Subject: Nine Mile Point 2 OL Safety Review - Request for Additional Information

NINE MILE POINT 2 - OL REVIEW
STRUCTURAL QUESTIONS

Review Questions - Geotechnical Engineering

Auxiliary Systems
Request for Additional Information
Nine Mile Point Unit 2

EXAMPLES OF ASSOCIATED CIRCUITS OF CONCERN

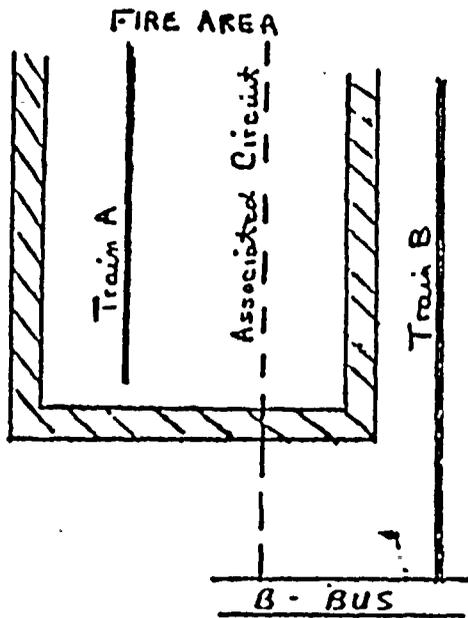
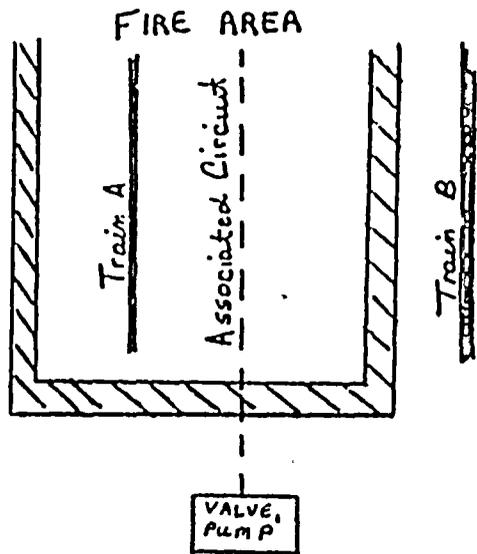
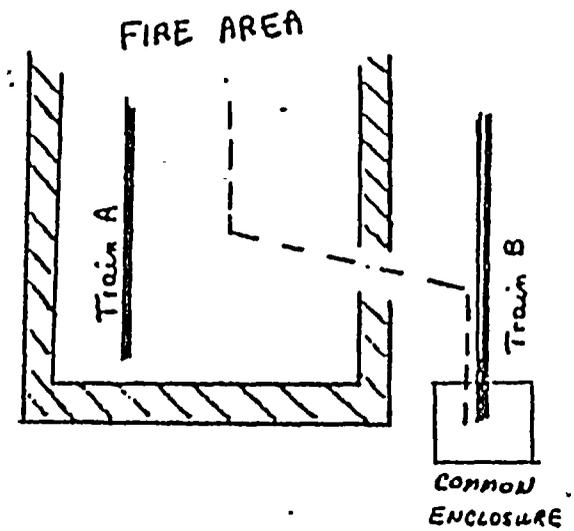
- (2) will allow propagation of the fire into the common enclosure, (see diagram 2c).

The area barriers shown above meet the appropriate sub-paragraphs (a-f) of section III.G-2 of Appendix R.

B. The following guidelines are for protecting the shutdown capability from fire-induced failures of circuits (cables) in the fire area. The shutdown capability may be protected from the adverse effect of damage to associated circuits of concern by the following methods:

1. Provide protection between the associated circuits of concern and the shutdown circuits as per Section III.G.2 of Appendix R, or
